**MCPB**  
**Item No.:** 11  
**Date:** 10-12-2017

**McLean School Mandatory Referral-MR 2018002**

**McLean School-MR 2018002:** Mandatory Referral for proposed building modifications at the former Tuckerman Elementary School, also known as the McLean School K-12, a private educational Institution located at 8224 Lochinver Lane, Potomac, 300 feet east of Candlelight Lane, 9.13 acres, R-90 Zone, *2002 Potomac Subregion Master Plan*.

Figure 4: Mandatory Referral Site Plan

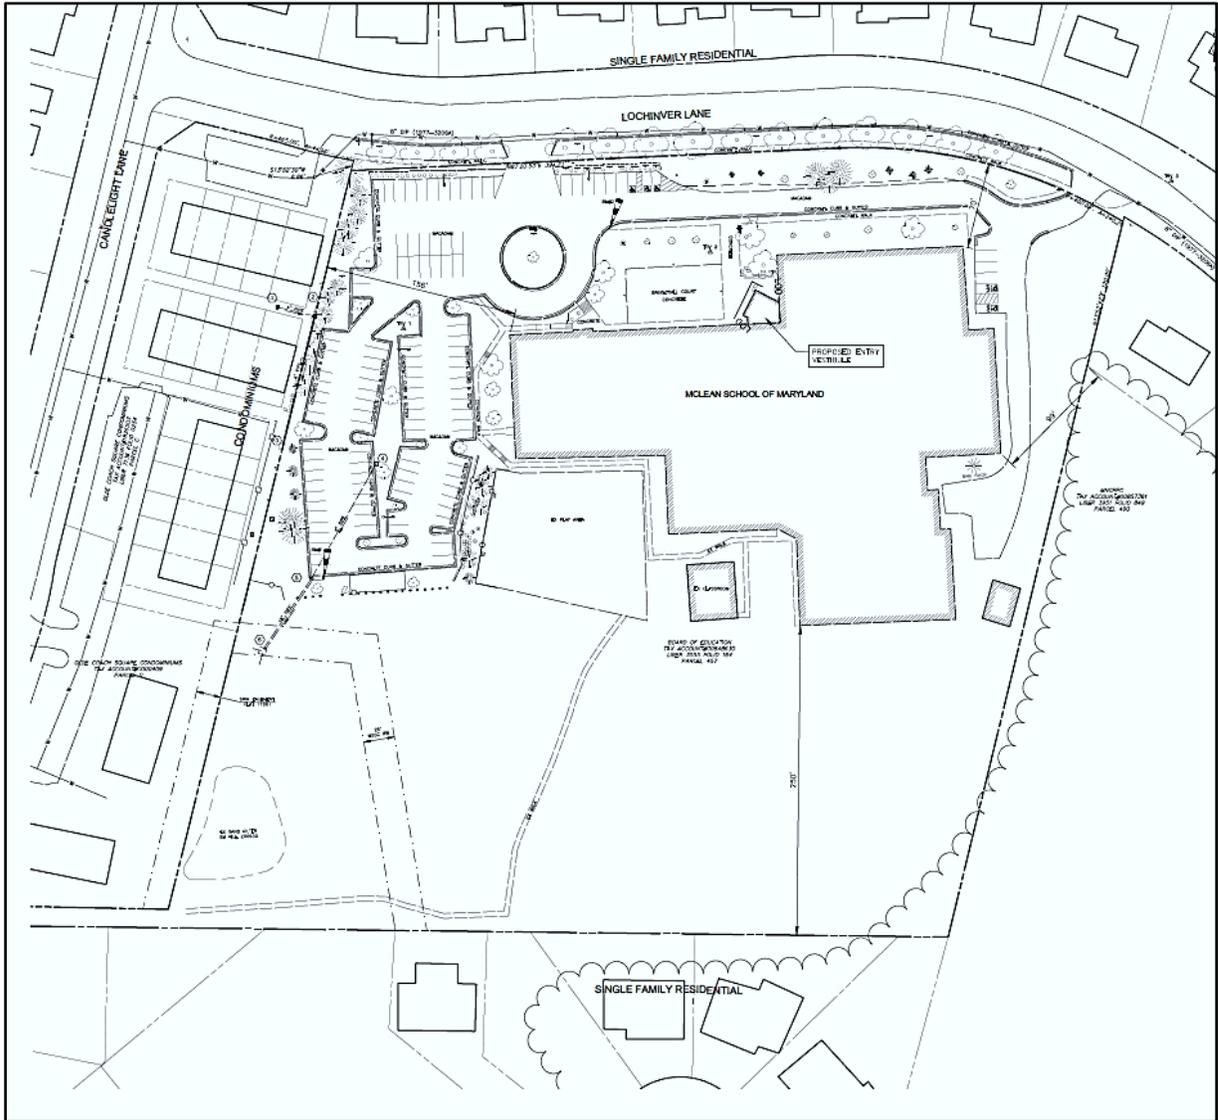
The site plan does not provide the required two-percent Motorcycle parking. The applicant indicated that There are no students or faculty that drive motorcycles, and McLean has not had any motorcycle use on the Property.

The revised site plan provides a bike rack on site which can accommodate 10 bicycles. The applicant indicated that the school does not have any student riding a bicycle to school. Given the dispersed nature of the student population, bike riding is not a realistic option for students. The Applicant further stated that should there be a unique situation where a student does live close and can ride their bike to school, the existing bike rack would more than satisfy those students.

Figure 5: Recommended Pedestrian crossings

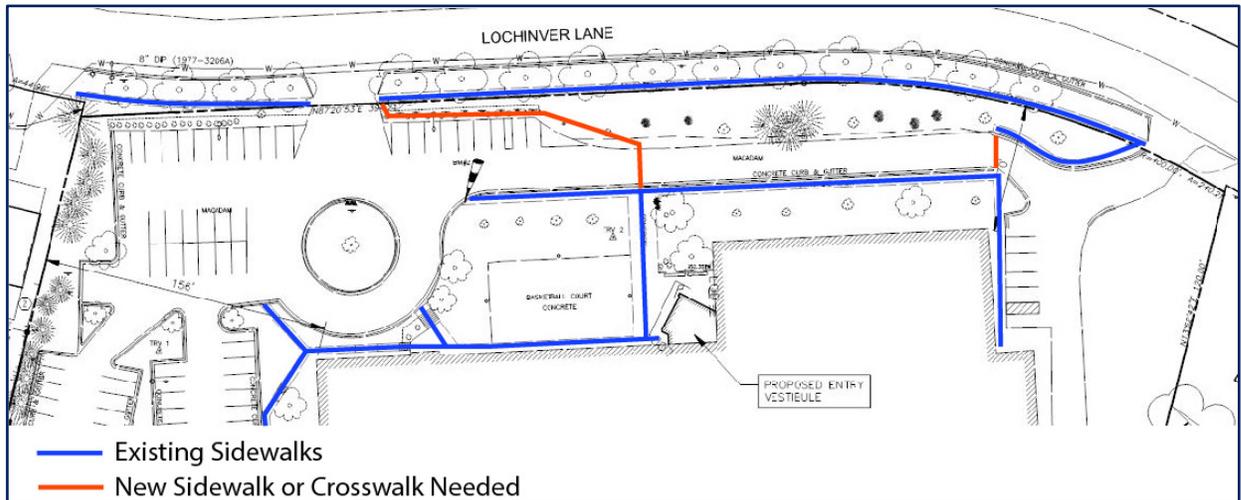
Pedestrians walking to the school from the west must cross through the grass or the parking lot to get to the school’s front entrance. They must also cross the main drive aisle. To ensure safe access for all students and reduce vehicular-pedestrian conflicts, a lead-in sidewalk should be added connecting the existing public sidewalk on Lochinver Lane near the west vehicle entrance to a point opposite or near the school sidewalk leading to the school entrance. Crosswalks should also be provided where pedestrians cross the vehicular drive aisle from the existing and future sidewalks to the school’s sidewalk (see graphic below).

1. Provide lead-in sidewalks and crosswalks from the public sidewalk across the drive aisle/parking lot to school sidewalks on both sides of the school (near both west and east vehicular entrances) to provide safe and adequate pedestrian access to the building for those walking to the school given the number of vehicles that circulate through the parking lot. Show these new facilities on the plans (Figure 5).
2. Request Montgomery County Department of Transportation to construct sidewalks on nearby residential roadways including the remainder of Lochinver Lane and Candlelight Lane to provide safe routes to the school.

3. The Applicant and facility must comply with all applicable sections of the County Noise Ordinance (Chapter 31B of the County Code).
4. The Applicant must provide a lead-in-sidewalk and crosswalk across the drive aisle/parking lot to school sidewalks on both sides (near both west and east vehicular entrances) to provide safe and adequate pedestrian access to the building for students and staff walking to the building. These new facilities must be shown on the plans.
